Residential apartment, Tower-final QA and handover snag list

Job Reference: US-F033-NYC

Auditor Name: Jason Patel

Auditor Company Name: Urban QA services LLC

Wardrobe Handle Loose and Wobbling

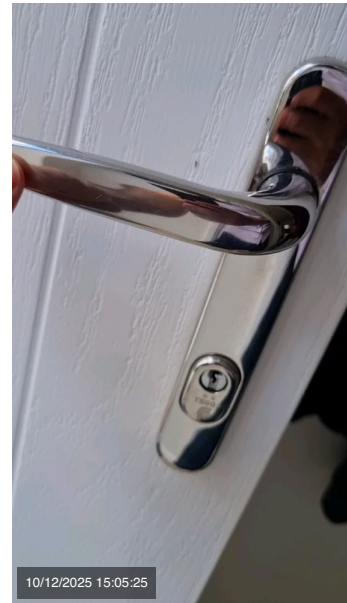
The metal handle on wardrobe door is loose, causing improper grip. Tighten screws or replace hardware to match existing finish.

Ceiling Patch Marks Visible After Repair

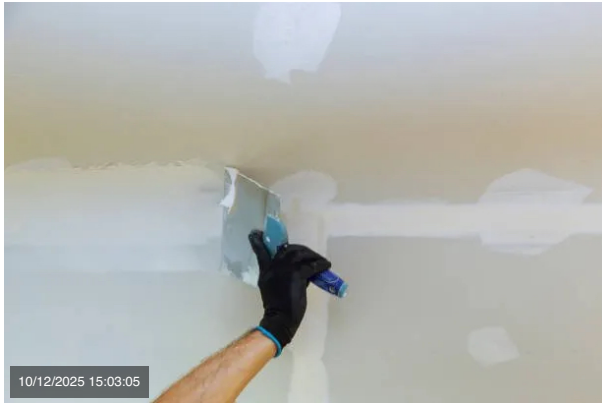
The false ceiling shows patchy texture where repair work was carried out. Needs surface sanding and uniform repainting for a smooth finish.

Bedroom Window Glass Scratched

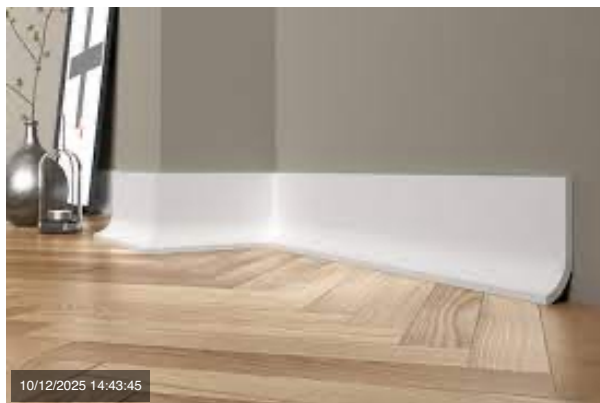
Sliding glass panel has visible scratches affecting clarity. Replace the damaged panel and verify frame alignment after installation.

Missing Skirting Board in Living Room

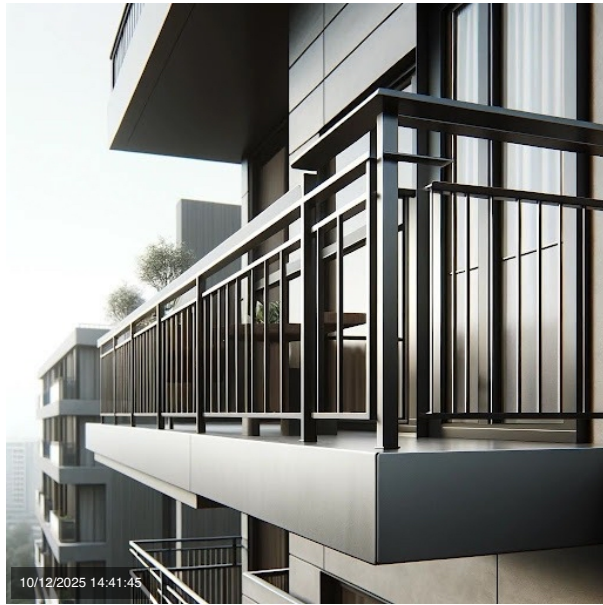
Skirting strip missing along the wall behind sofa placement. Needs installation of matching finish skirting and proper adhesive fixing

Water Leakage Behind Bathroom Wall

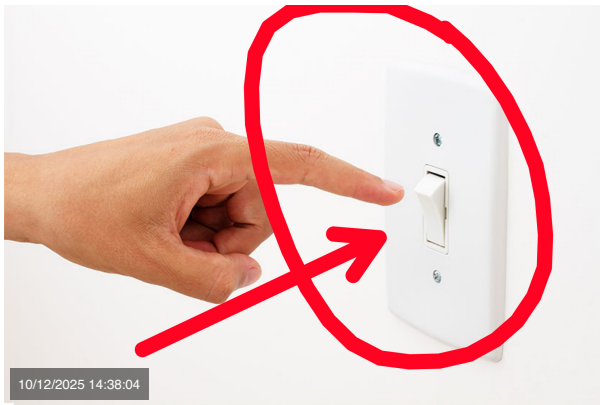
Damp patch observed behind WC area. Suspected leakage from concealed plumbing line. Wall needs inspection, rectification, and retiling after repair.

Cracked Floor Tile Near Kitchen Entry

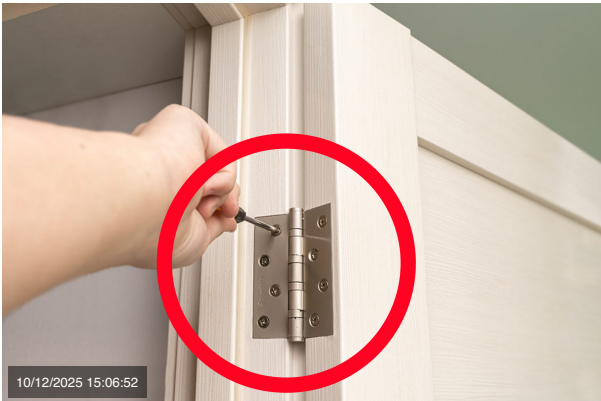
One ceramic tile at the kitchen threshold is cracked, likely due to impact during installation. Tile must be replaced and grout color matched.
